REQUEST

Current Zoning: B-1 PED (neighborhood business, pedestrian overlay) and MUDD (mixed use development district,)
Proposed Zoning: MUDD-O PED (mixed use development district, optional, pedestrian overlay)

Approximately 1.474 acres located on the southeast side of Euclid Avenue, southwest of Royal Court, and northeast of Morehead Street.

The petition proposes to allow a multifamily residential development in a single building.

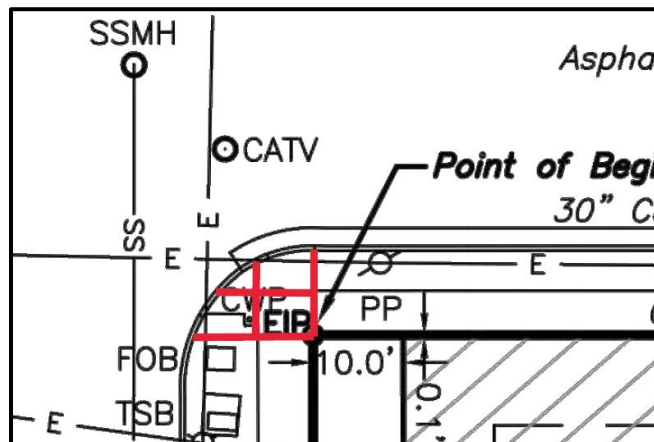
1. Add an optional provision to allow the setback to be decreased from 16 feet to 14 feet per *Section 10.805. Pedestrian Overlay District (Optional); Purpose.*
2. Further develop architectural and design standards to better address breaking up the massing and scale of the building. Architectural Standards Note 5(b)(8) proposes a 5-foot step back minimum that is much less than the 11+ feet discussed earlier. Please increase to a minimum of 8-10 feet.
3. Show, label, and dimension all public street centerlines to the future back of curb.
4. Show, label, and dimension the setback from the future back of curb which will include the required planting strip and sidewalk.

5. Please extend the left-sight line through the intersection of Euclid Avenue & East Morehead Street to account for the Euclid Avenue eastbound-thru green phase. The intersection sight distance plan and profile may be reviewed during permitting.
6. Please revise the site plan and conditional note(s) to include the construction of two curb ramps at the east quadrant of the East Morehead Street & Euclid Avenue Intersection.
